GMN ERR
Charges 6 and 7
Jay Benesch

Charge Items

- 6. Is the beam delivery affected by the running configuration of BigBite and SBS? If yes, have the fringe field effects been properly mitigated?
- 7. Are the beam commissioning procedures and machine protection systems sufficiently defined for this stage?

Stray field along Z axis ($x, y = 0.707$ cm)

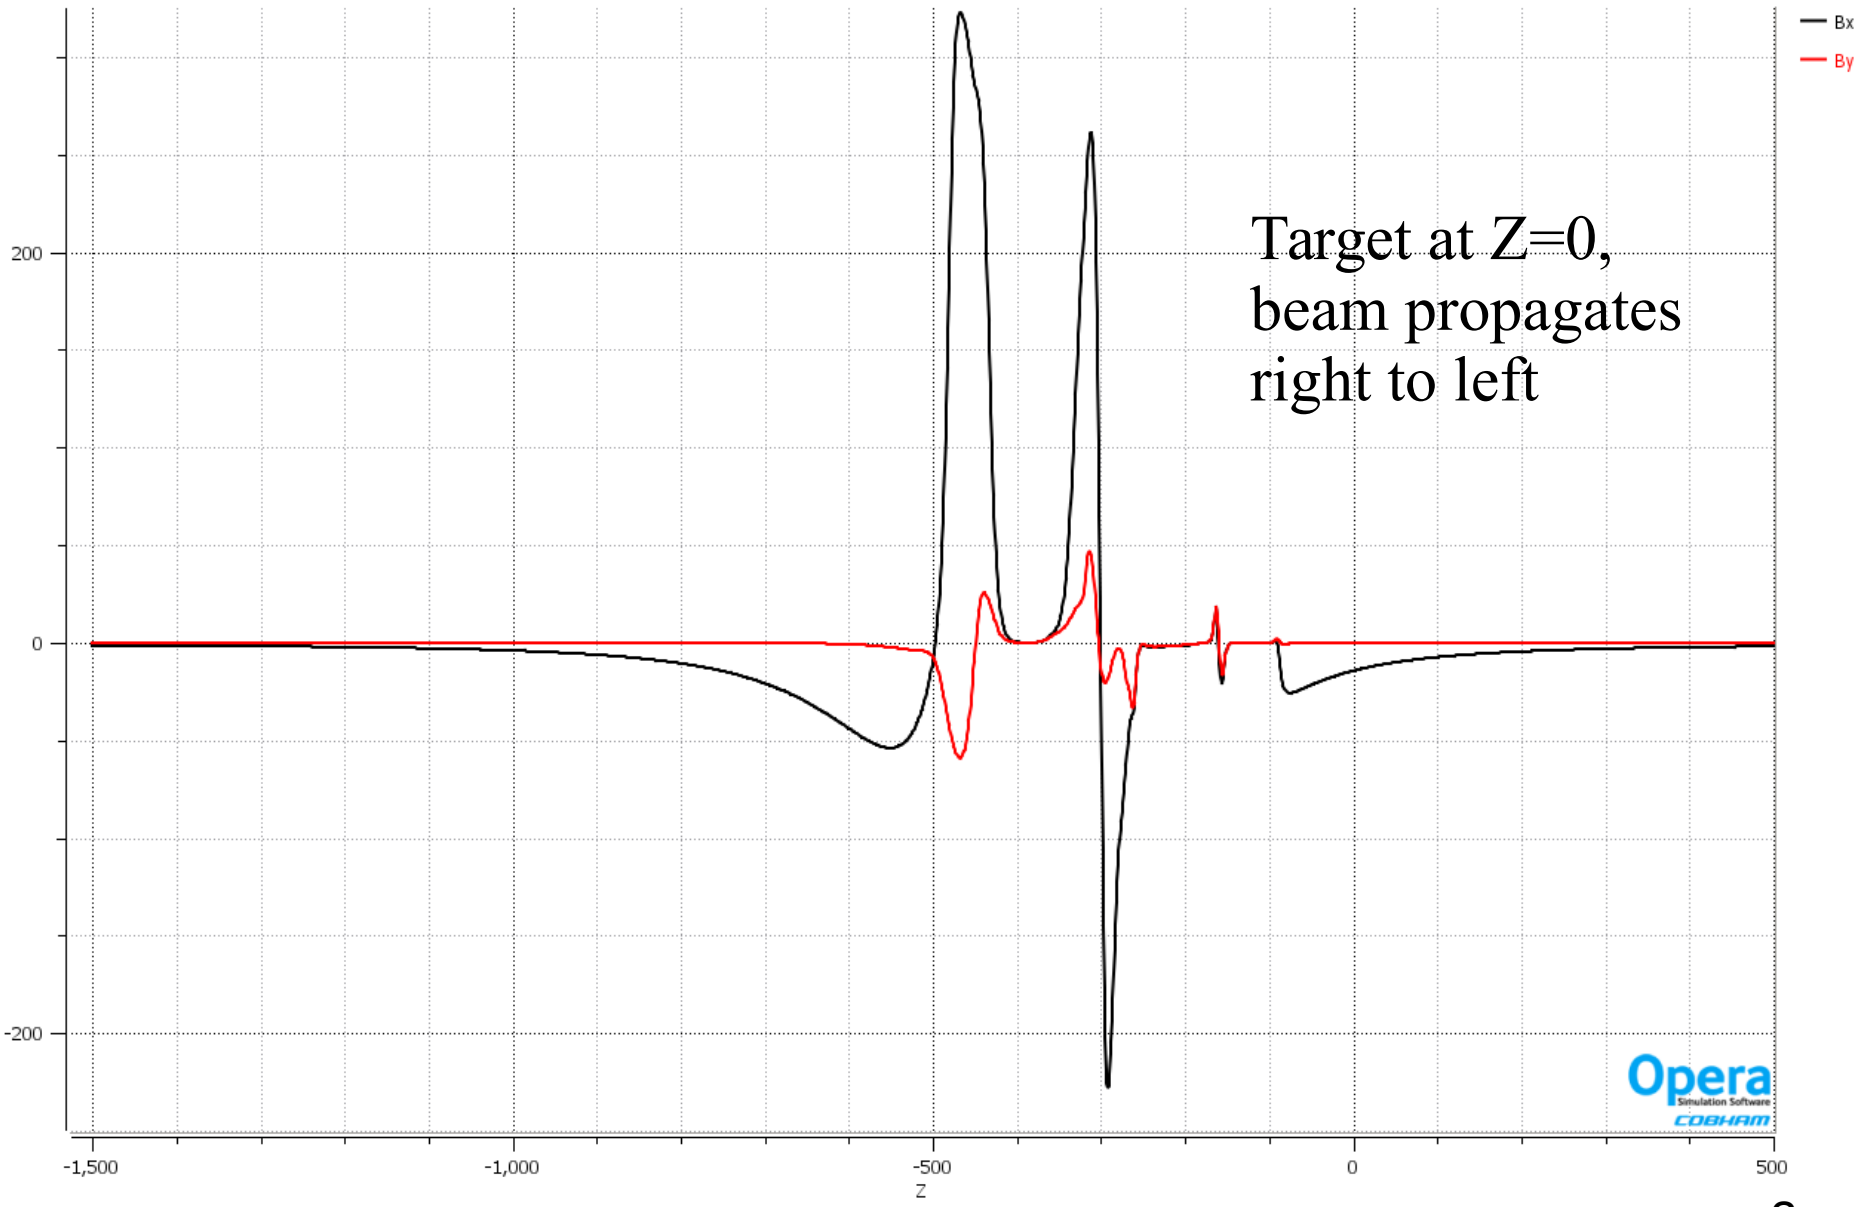
- Opera Modeller file received from Bogdan Wojtsekhowski May 16. I meshed and solved it. Field integral 1.56 Tm vs 1.71 Tm maximum.
- Integrated Bx field along central primary beam orbit was ~ 5 kG-cm so I adjusted the downstream correctors to lower it. Upstream correctors have much more headroom; I chose to change only downstream, maintaining Bogdan's ratio between left and right.

- Decreased mesh size and increased volume meshed to insure fields in the region of interest were not affected by the zero forced at the boundary.
- Downstream corrector excitation was increased to reduce Bx; By increased modestly as a result of steel interactions. Current densities of 900 A/cm^2 and 1050 A/cm^2 were required to get Bx and By integrals down to acceptable levels. Correctors are water cooled and upstream correctors are barely used (0 and 75 A/cm^2) so fringe fields should be correctable even with 10% more excitation.

- **If** downstream correctors can each be powered and cooled to provide 42 kAT the fringe field effects have been mitigated. (38 kAT needed for 1.56 Tm, 90% of full magnet capability.) Upstream correctors have full capacity available; I simply chose not to use them.
- The only significant multipole is skew quadrupole, integral dZ -812 G. This is of the same order as the skew quadrupole of the Lambertson and is not an issue for round beams. It rotates the 5x5 arrays a little as shown on the previous slide.
- Power supply controls of downstream correctors should be ganged left:right in 6:7 ratio to simplify Operations steering to dump viewers.
- All calculations were done with main SBS coil currents as supplied by B. Wojtsekhowski, field integral 1.56 Tm.

11 GeV particle array

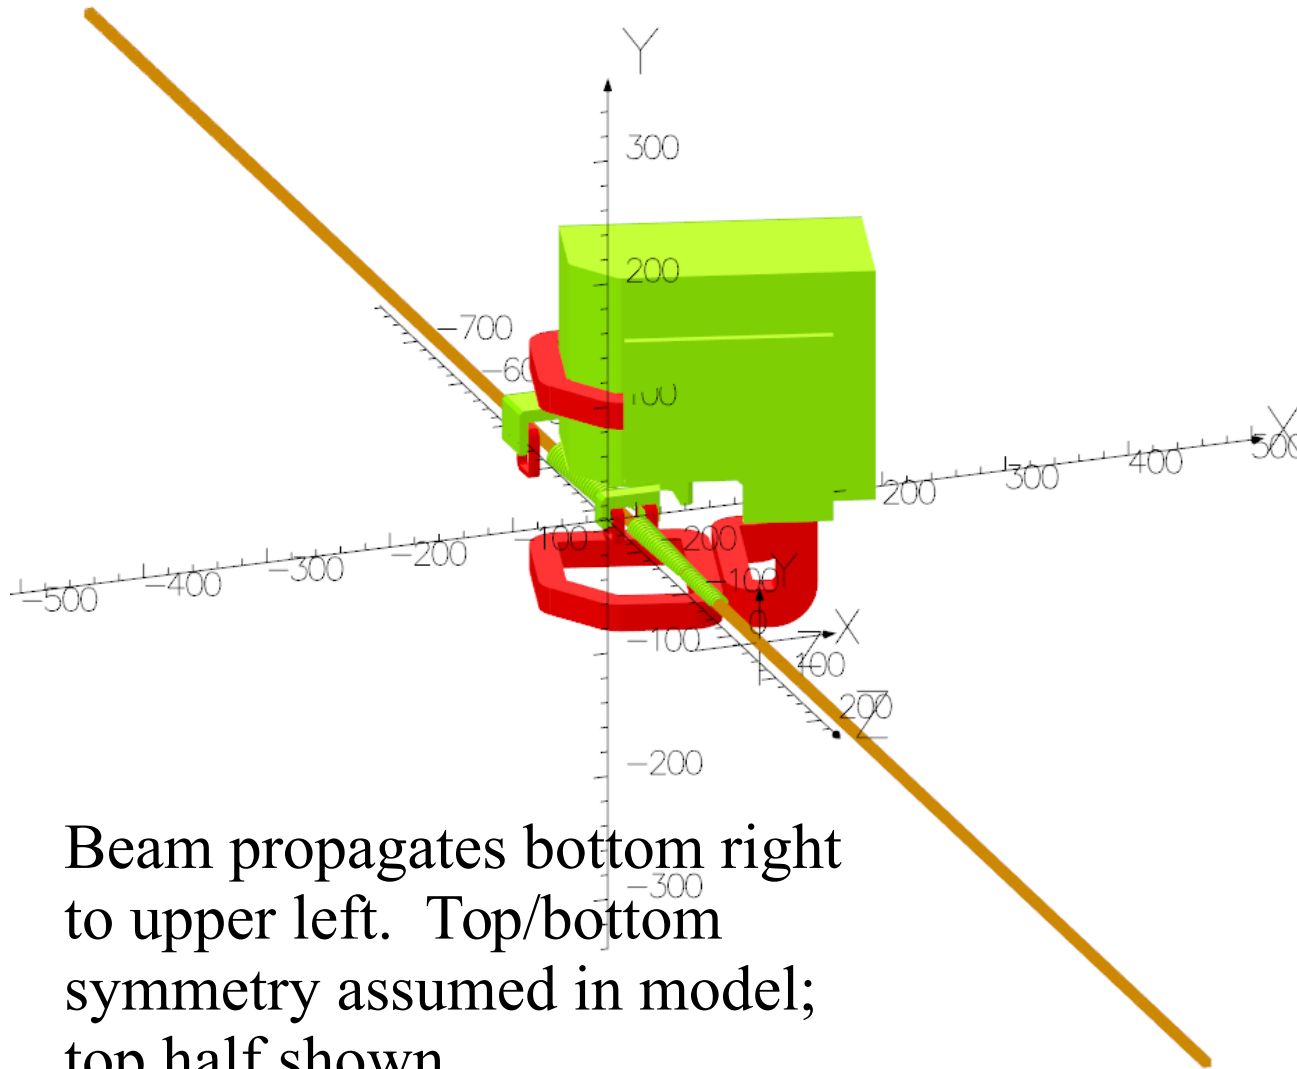
Beam propagates bottom right to upper left. Top/bottom symmetry assumed in model; top half shown.

4.48 GeV particle array

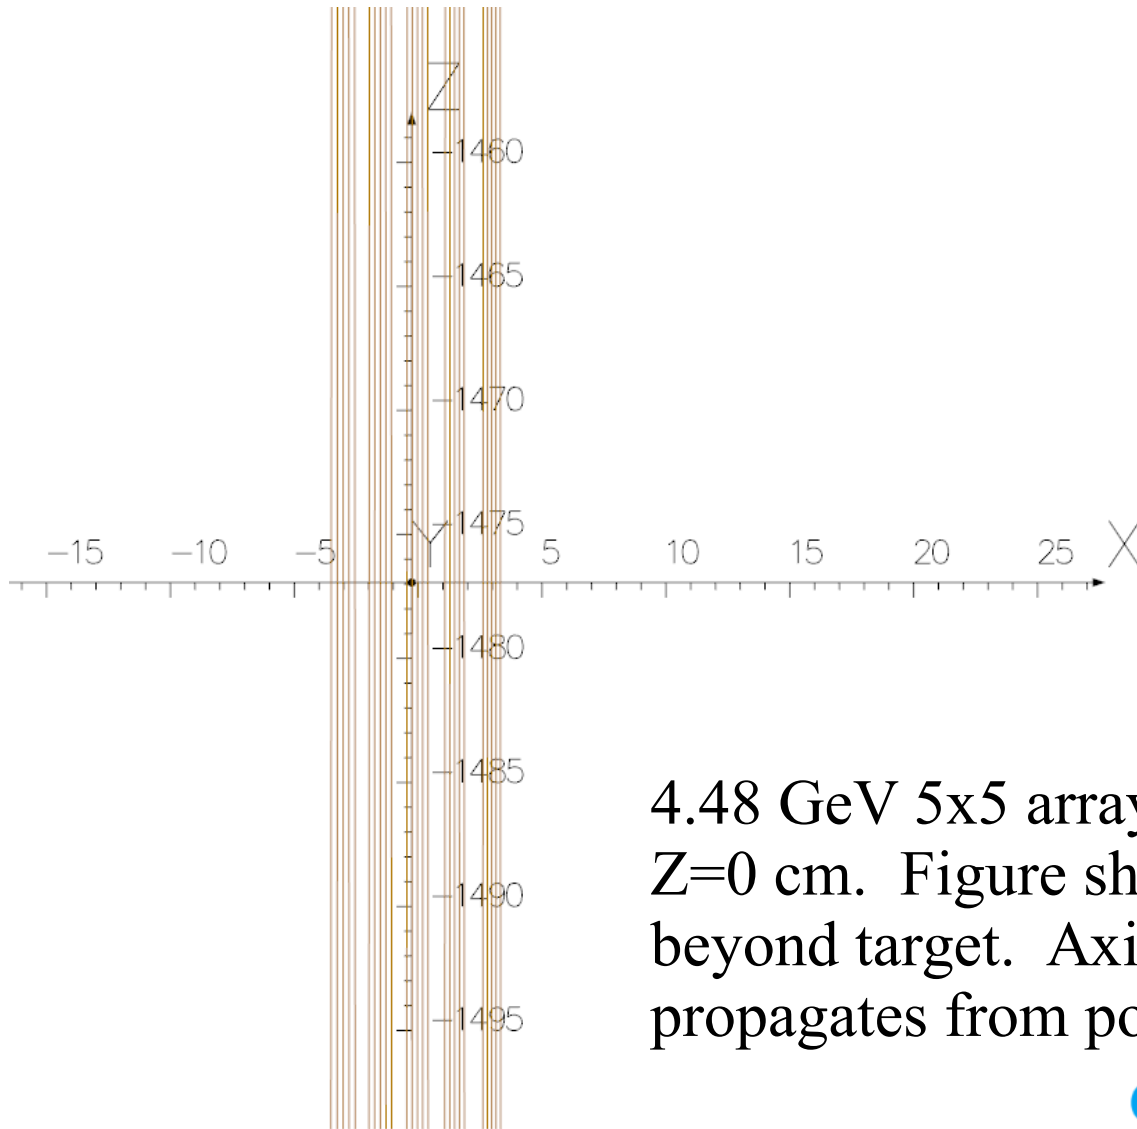
4.48 GeV 5x5 array, 6 cm square, launched at Z=0 cm. Figure shows X deflections 1500 cm beyond target. Axis scales cm. Beam propagates from positive to negative Z.
